RESPONSE TO IAPUM ADVICE

Russell Vale Colliery Revised
Underground Expansion Project
MP09_0013

Prepared by
Umwelt (Australia) Pty Limited
on behalf of
Wollongong Coal Limited

Project Director: **Barbara Crossley**
Project Manager: **Gabrielle Allan**
Technical Director: **David Holmes**
Report No. **3687D/R19**
Date: **November 2020**

Figure 2.1 Marginally Stable Pillars

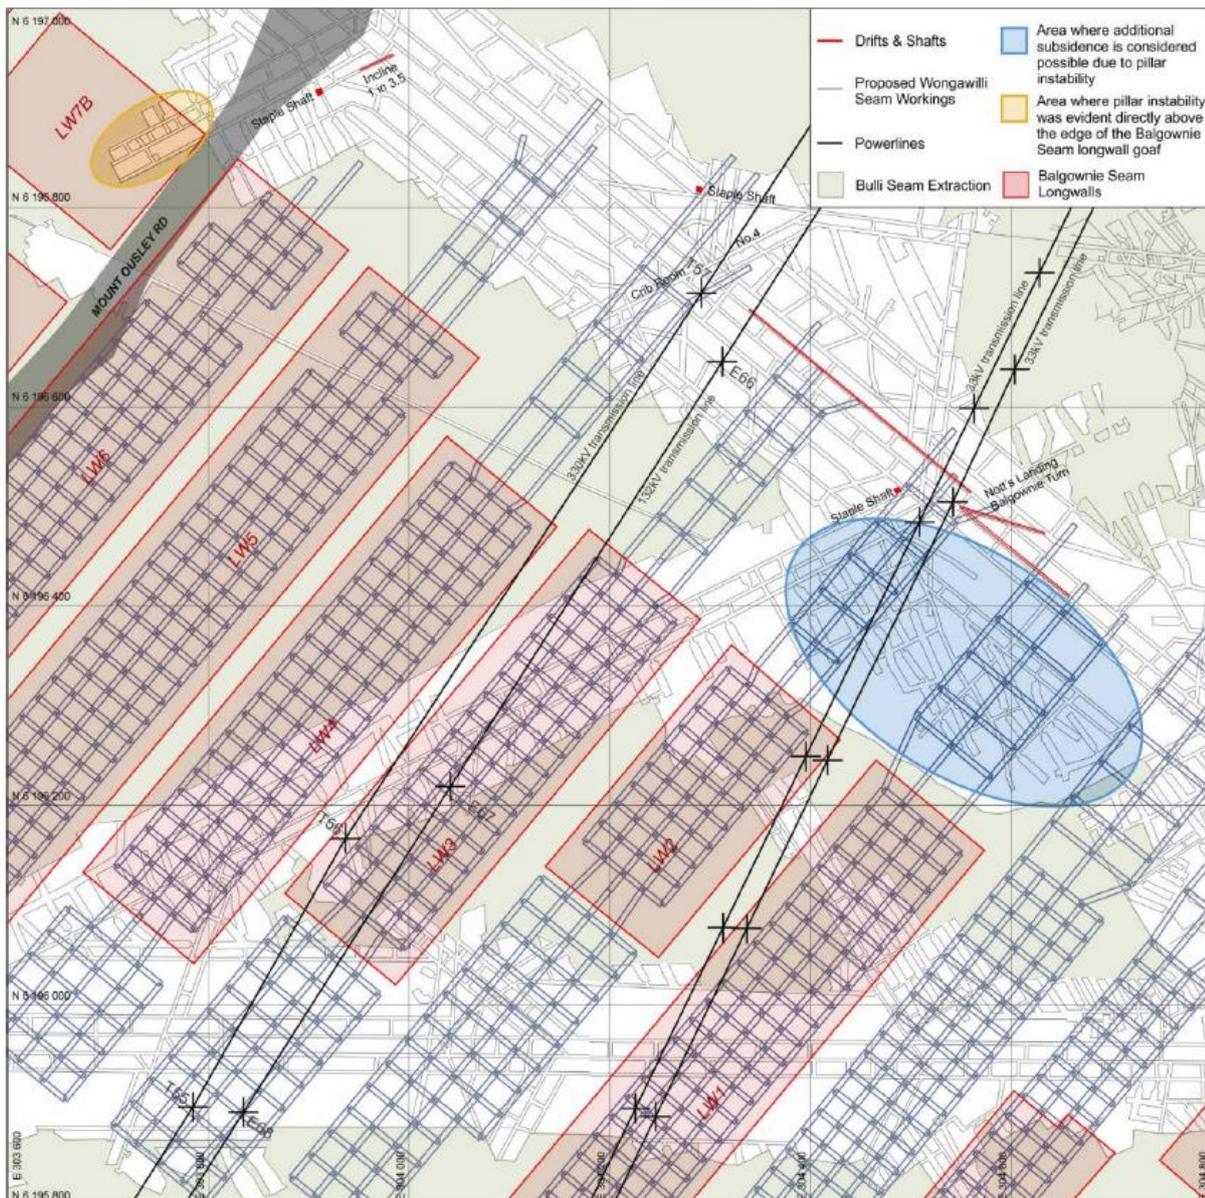
The phrase 'marginally stable pillars' and discussion around 'potential pillar instability' relates to consideration of irregularly shaped bord and pillar workings adjacent to the Bulli Seam main headings. These are shown in Figure 16 of the SCT Subsidence Assessment (reproduced below in **Figure 2.1**). The SCT Subsidence Assessment includes the following commentary regarding these 'marginally stable pillars':

It is therefore important to recognise that the consequences of subsidence associated with the failure of these marginally stable pillars is almost certain to occur at some time in the future irrespective of whether or not the Project proceeds. The Project therefore does not cause the subsidence impacts that will arise from the eventual failure of these pillars (this is the result of historical mining which occurred prior to 1950), however the potential for the Project triggering the failure of these pillars cannot be ruled out.

None of the marginally stable pillars are located below swamps nor is the failure of these pillars likely to impacts on any creeks, cliff lines or rockshelf features. As such, the environmental impacts of a failure of these pillars is likely to be negligible. These pillars are however located in close proximity to high voltage transmission line towers (refer to **Figure 2.1**) and the detailed mine design will need to have regard to the management of these features. This is discussed further in **Section 3.0**.

Figure 2.2 Areas of Secondary Extraction

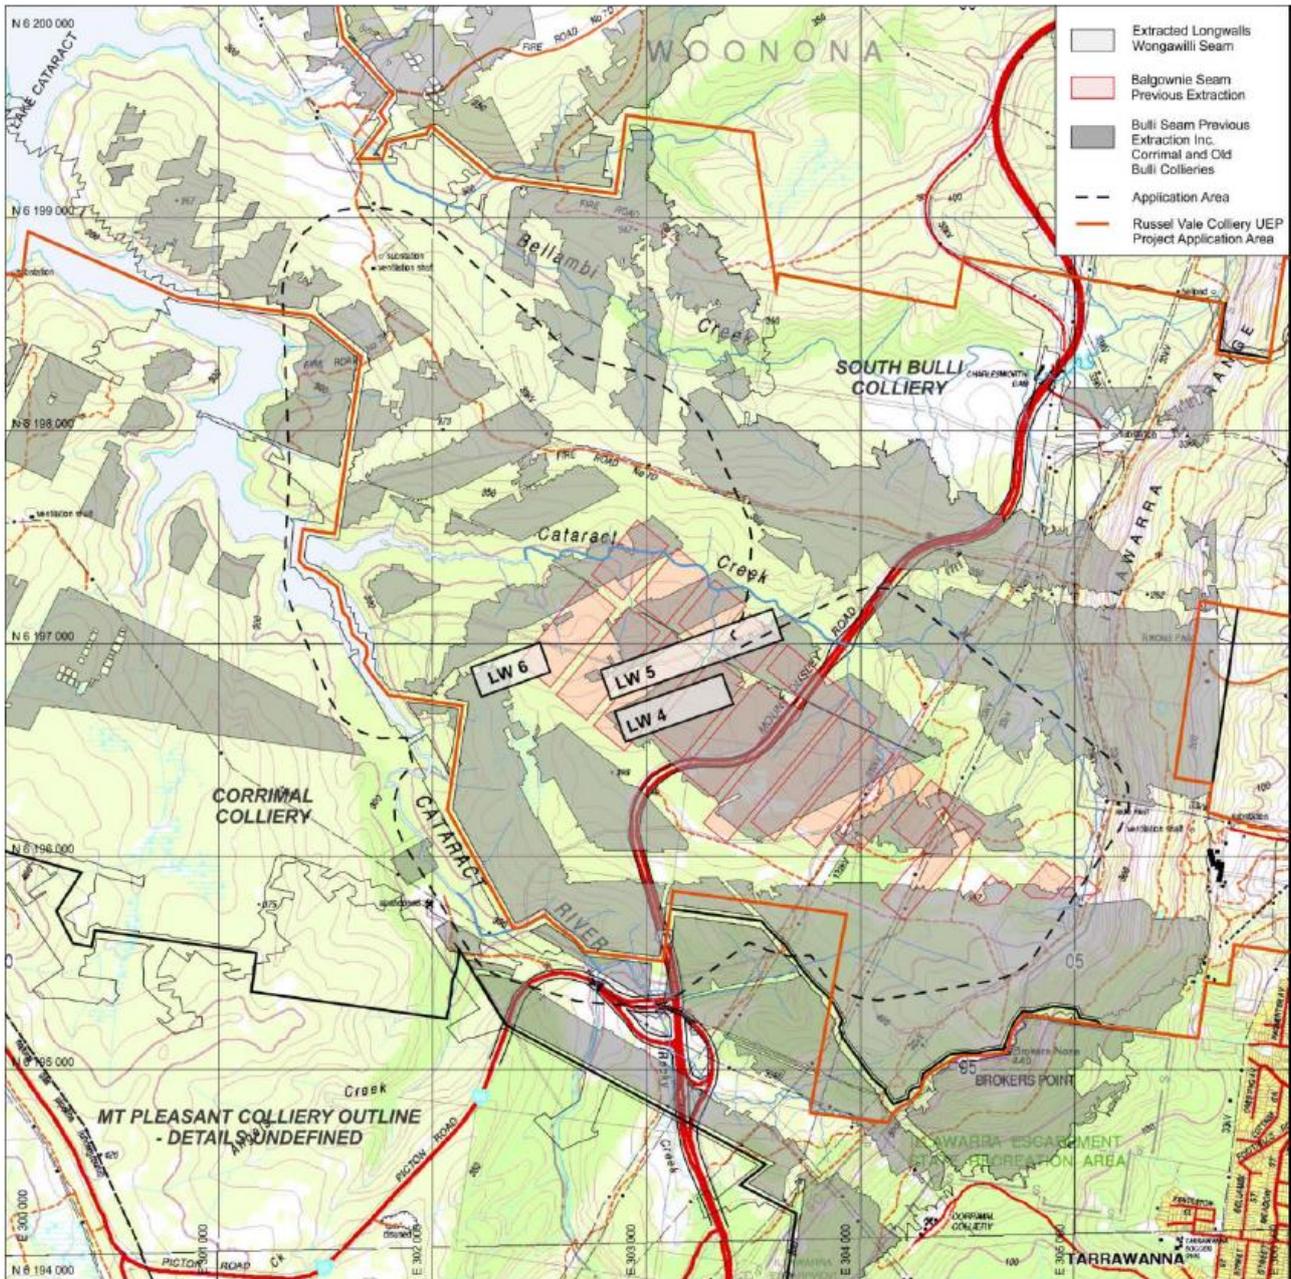
The use of the phrase ‘standing pillars’ in this Report relates to the potential for there to be remnant pillars or parts of pillars remaining within areas shown on the Bulli Seam record tracings as shaded (refer to black/grey areas in Figure 14 of the SCT Subsidence Assessment - reproduced in **Figure 2.2**) which have potential to fail. These areas are described in the SCT Subsidence Assessment as follows:

Where large areas have been shaded (refer to Figure 14) to represent the completion of mining, the detail of the Bulli Seam extraction is not available. These areas are likely to include different levels of mining ranging from solid coal, large standing pillars, standing pillars associated with Welsh bords, and goaf areas where there has been pillar extraction or the pillars have previously collapsed.

SCT remain of the view that it is extremely unlikely that the proposed first workings below any of these standing pillars will further destabilise them however it is acknowledged that it cannot be entirely ruled out. However, as with the marginally stable pillars, the Project will not increase the consequences associated with these pillars failing (other than the predicted incremental subsidence associated with the proposed first workings) in that these consequences will eventually occur (if they haven't already) irrespective of the Project proceeding. The Project could however bring the timing of these consequences forward if the works did result in destabilisation.

Figure 2.3 Goaf Areas Considered in SCT Subsidence Risk Assessment

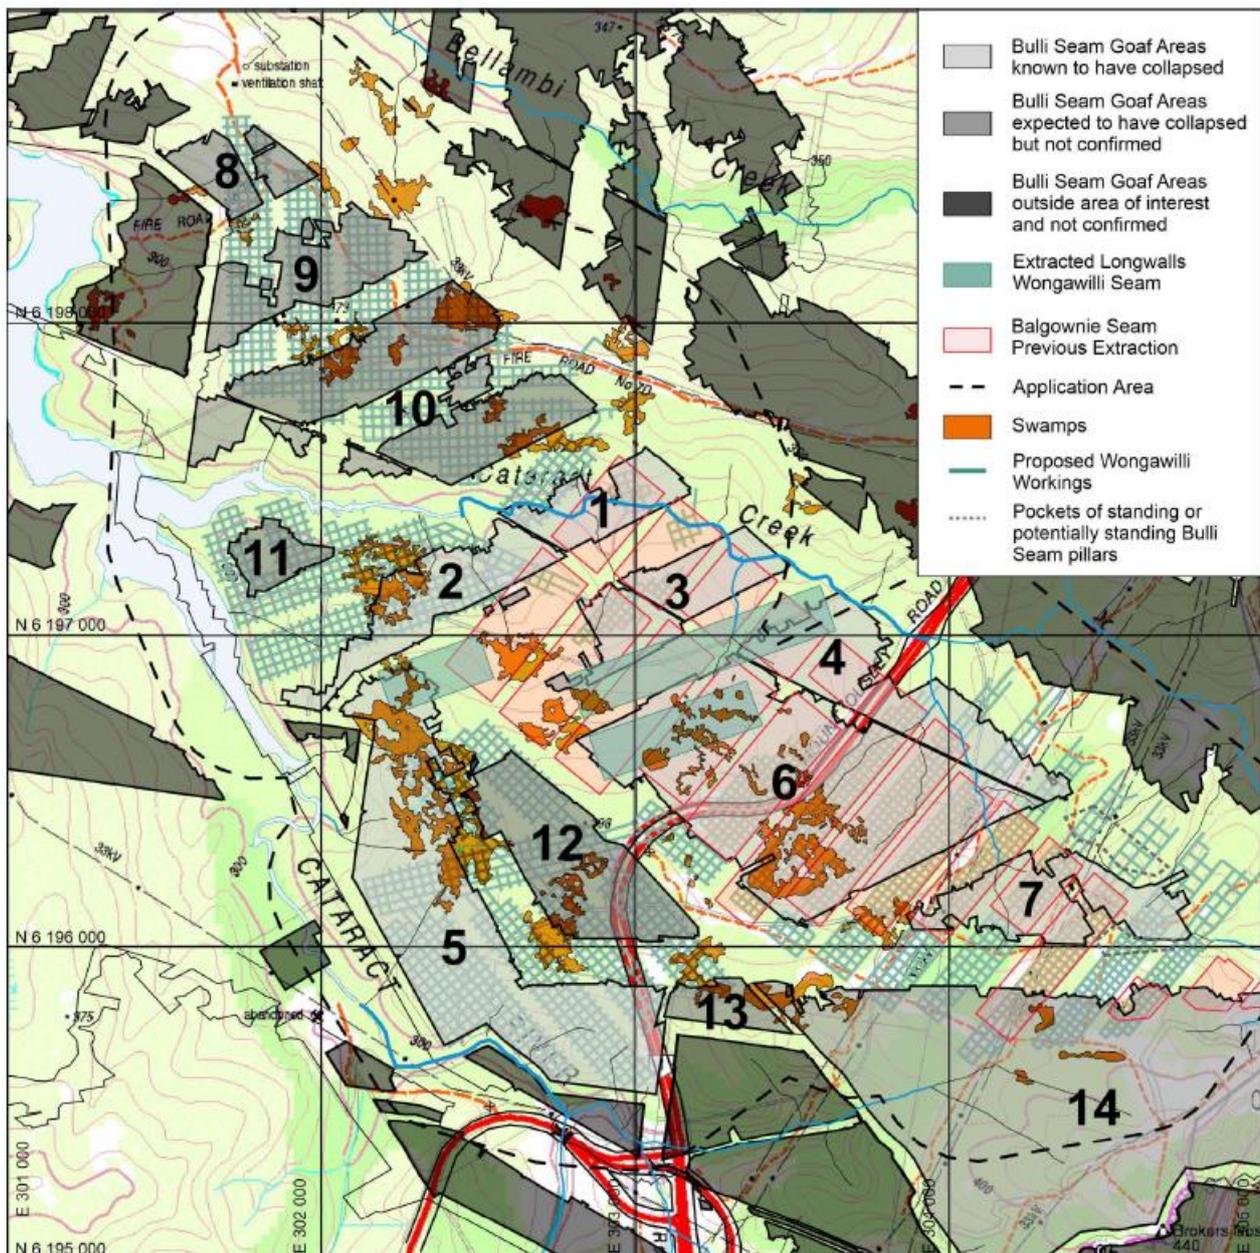
These grey/black shaded areas correspond to the 14 ‘Bulli Seam goaf areas’ considered in the SCT Subsidence Risk Assessment (SCT, 2020: refer to Figure 1 in the SCT Subsidence Risk Assessment – reproduced in **Figure 2.3**). Section 2.3.2 of the SCT Subsidence Risk Assessment (SCT, 2020a) describes these areas as follows:

Figure 1 shows fourteen large areas of Bulli Seam pillar extraction, referred to as Bulli Seam goaf areas. There is evidence available from subsidence monitoring and observation of roadway conditions in the Wongawilli Seam to confirm seven of these areas have fully collapsed with no potential for further subsidence. The seven collapsed goaf areas are numbered in Figure 1 as 1-7.

It is almost certain that the other seven goaf areas (8-14) have also fully collapsed because the mining systems used in each are similar and the areas extracted are of similar size. Confirmation of collapse in all these areas would be reassuring for the sake of completeness. Proposed mining in the Wongawilli Seam would not change the potential for further subsidence from the Bulli Seam. This potential would exist irrespective of proposed mining. The benefit of knowing that all the Bulli Seam goaf areas have collapsed and fully subsided is that this risk could then be eliminated.

Figure 2.4 Upland Swamps Considered by IAPUM

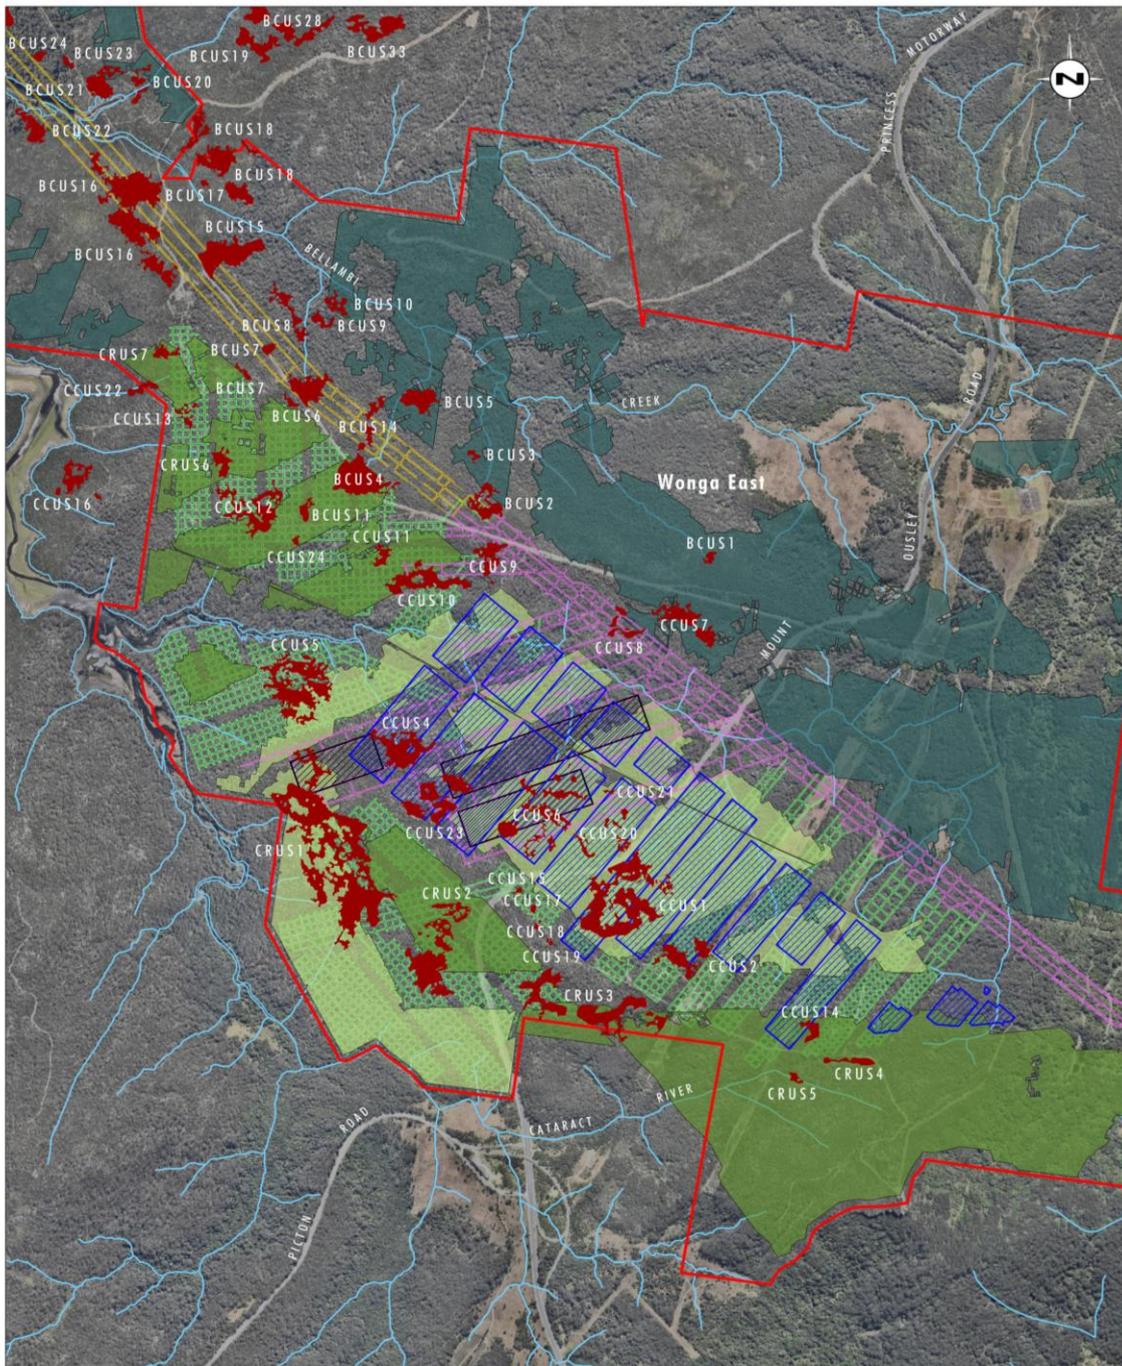
The four upland swamps identified in the IAPUM Advice as already having experienced tensile strain impacts of over 10 mm/m (CCUS1, CCUS6, CCUS20 and CCUS21) are all located over Area 6 (refer to **Figure 2.4** and **Table E.1.1** in **Appendix E**). Area 6 is one of the Bulli Seam goaf areas confirmed as having been fully collapsed. Of these four swamps, neither CCUS6 and CCUS21 will be directly undermined by the proposed first workings in the Wongawilli Seam and are unlikely to experience any additional subsidence effects from the proposed mining.

The Extraction Plan(s) and Subsidence Principal Hazard Management Plan(s) developed for the first workings potentially affecting swamps CCUS1, CCUS6, CCUS20 and CCUS21 will have specific regard to any updated subsidence, groundwater and swamp monitoring in the development of the mine plan below and in the vicinity of these swamps. The mine plan and monitoring in these areas will require careful consideration of cumulative impacts on these swamps and the potential for tensile strains to exceed thresholds that may present a risk to these swamps.

Figure 1: Influence of extraction panel width-to-depth ratio, W/H , on maximum vertical surface displacement, $V_{z \max}$, expressed as a fraction of mining height, h , for isolated total extraction panels (adapted by Galvin (2016) from Whittaker and Reddish (1989)).

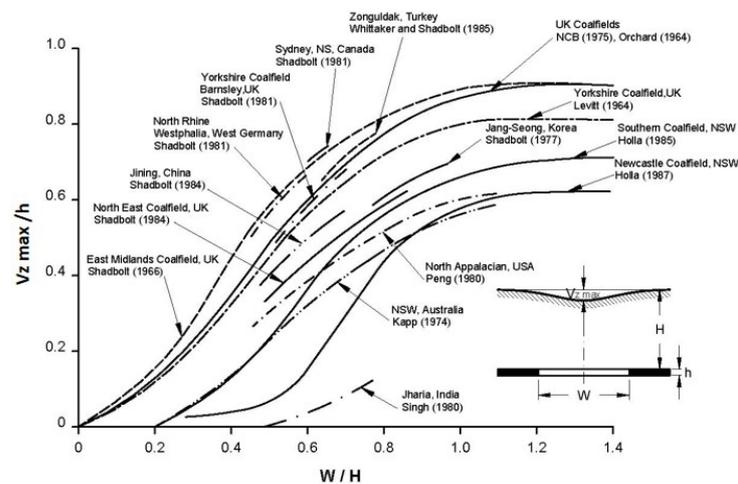
Based on the layout of mine workings shown in Figure 1, the lateral extent (W) of collapsed workings in Area 6 is much greater than their depth below surface (H). Consistent with the subsidence engineering principles shown in Figure 1, the floor of the Bulli Seam over most of Area 6 should therefore be subjected to full cover load. In turn, longwall mining in the Balgownie Seam will result in caving of the 5 to 10 m parting to the floor of the Bulli Seam and, thus, should result in the full cover load being transferred to the floor of the Balgownie Seam. This contrasts with the pillar stability analysis reported by SCT which is based on the pillars in the Wongawilli Seam only having to support some 65% of the overburden load. If the 19.5 m square pillars are subjected to full overburden load, their factor of safety drops to 1.4, corresponding to around a 2 in 100 likelihood of pillar failure, which is some 2000 times greater than for 24.5 m square pillars.

It should be recognised that the original figure that forms the basis for Figure 1 presented in the IAPUM report is slightly misleading in that the panel width (W) relates to the width of individual panels. This width is normalised when divided by overburden depth (H). However, the maximum subsidence normalised by dividing by mining height relates to the subsidence across multiple panels of width (W), not just a single panel as drawn. It is very unusual to see surface subsidence above a single panel when the panel width is less than one third of overburden depth. The guidelines from the Reynolds Inquiry (Reynolds 1977) take advantage of this geometry to control subsidence below stored waters.

Figure 2: Location and nature of workings in each of the three seams at Russell Vale, sourced from SCT (2020b) and annotated to identify longwall panel numbers in the Wongawilli Seam.

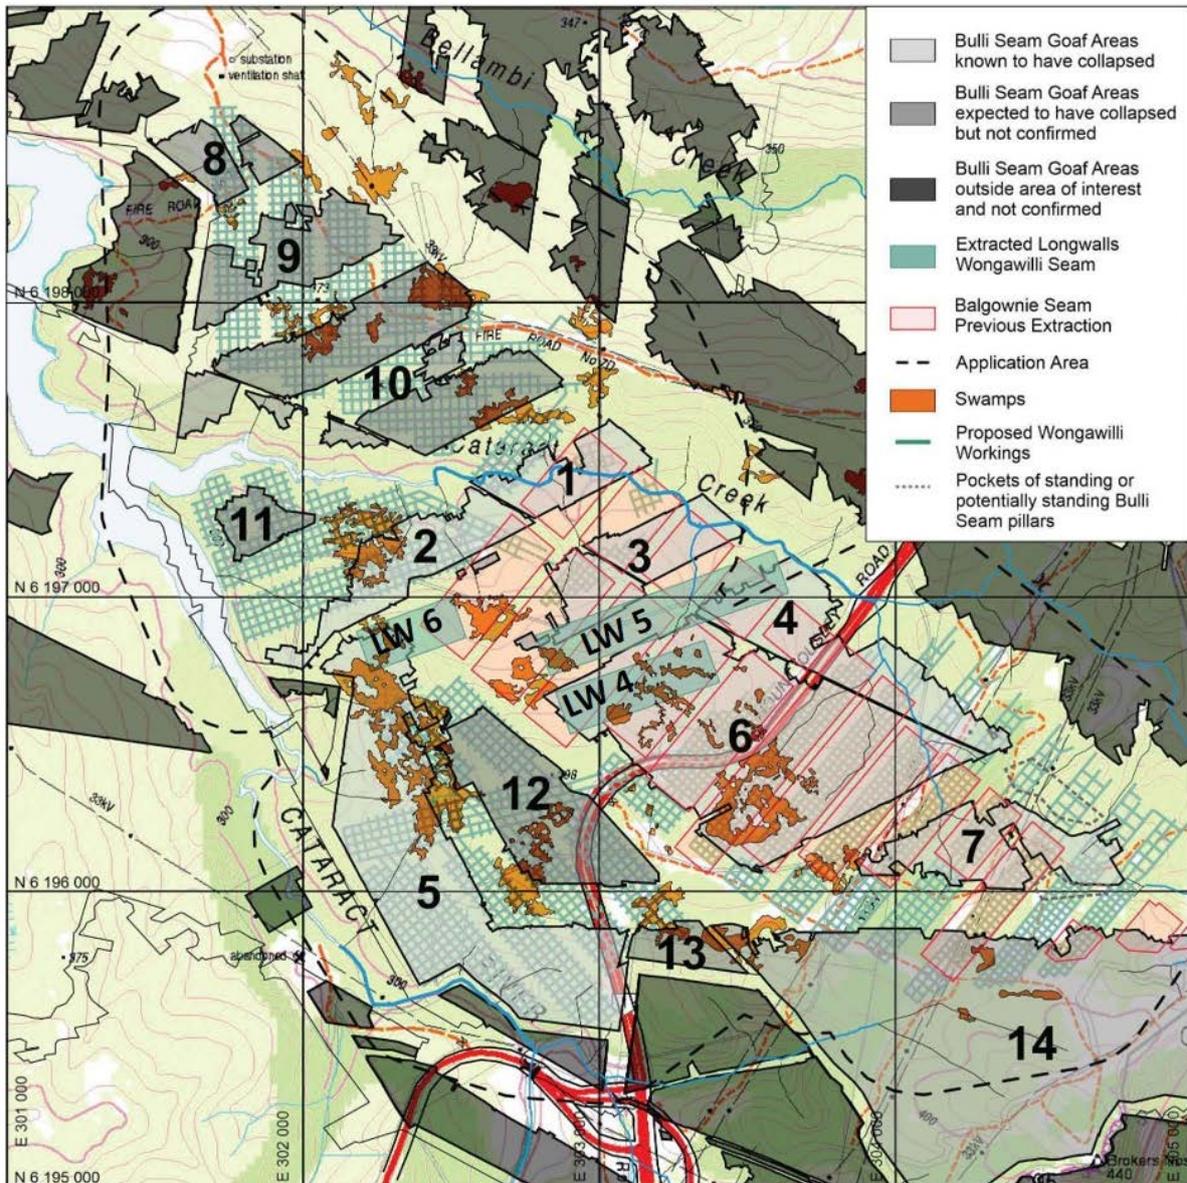
The proposed bord and pillar mining in the Wongawilli Seam underlies 14 areas where pillar extraction has been undertaken in the Bulli Seam. SCT (2020b) reports that seven of these areas, numbered 1 to 7 in Figure 2, are confirmed as ‘subsided’.¹¹ It goes on to state that

Reference to Figure 2 shows that these seven areas have been undermined by longwall mining in the Balgownie Seam, some 5 to 10 m below the Bulli Seam. The Panel interprets the SCT statement to mean that the subsidence measured as a result of longwall mining in the Balgownie Seam confirms that the workings were already in a collapsed state prior to longwall mining in the Balgownie Seam.

- The applicant proposes to identify the presence of unfailed pillar workings in the Bulli Seam on the basis of an absence of abutment stress in the Wongawilli Seam. This is considered feasible but the information provided to the Panel is too limited for it to determine if it will cover all situations (the only mine plan which the Panel has is that which constitutes Figure 2
